Office Action Summary	Application No. 10/717,321	Applicant(s) VON HOLDT, JOHN W.	
	Examiner Shawn M. Braden	Art Unit 3727

DETAILED ACTION

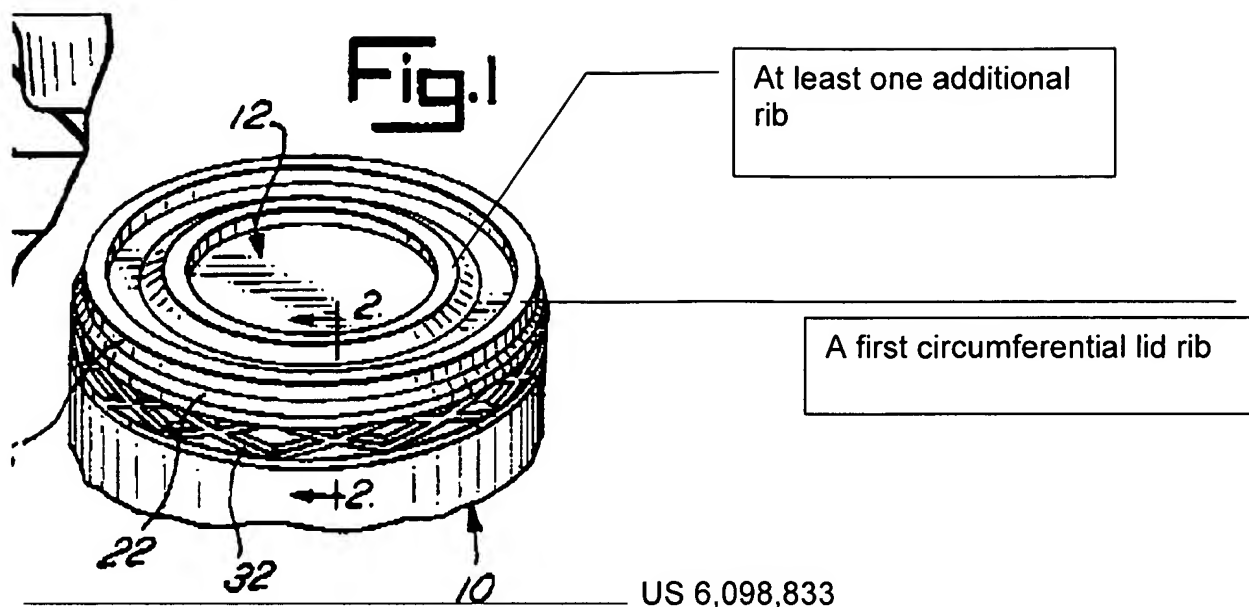
Von Holdt, Jr. teaches a bottom wall including an outside surface with a first, at least partially circumferential, depending rib and a second at least partially circumferential depending rib from the first rib, said ribs defining a circumferential groove therebetween having a first width (fig 6.) in the analogous art of buckets to facilitate stacking (col. 3 ln 24-34).

It would have been obvious to one having ordinary skill in the art at the time the invention was made to combine the teachings of the bottom surface including the ribs and the circumferential groove of Von Holdt Jr. to the bucket of Von Holdt Sr. in order to facilitate stacking.

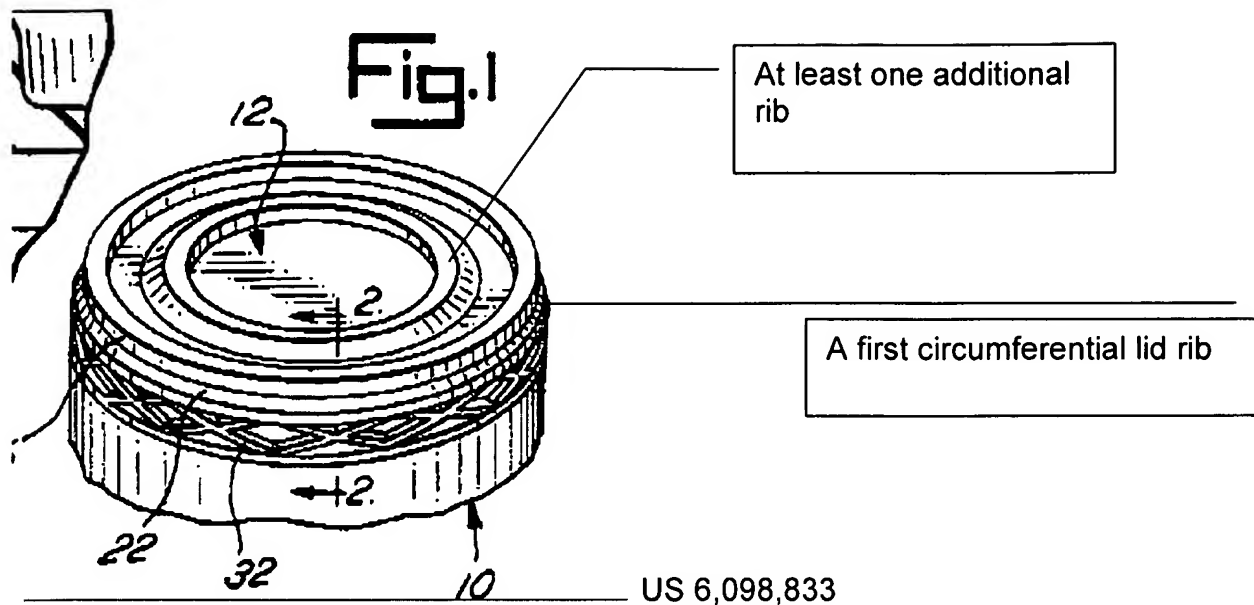
groove therebetween having a first width, this groove also fits the rib on the upper lid when stacked, in the analogous art of buckets for the purpose of adding strength and stacking.

It would have been obvious to one having ordinary skill in the art at the time the invention was made to combine the teachings of the bottom surface including the ribs and the circumferential groove of Breimon to the bucket of Von Holdt Sr. in order to facilitate stacking.
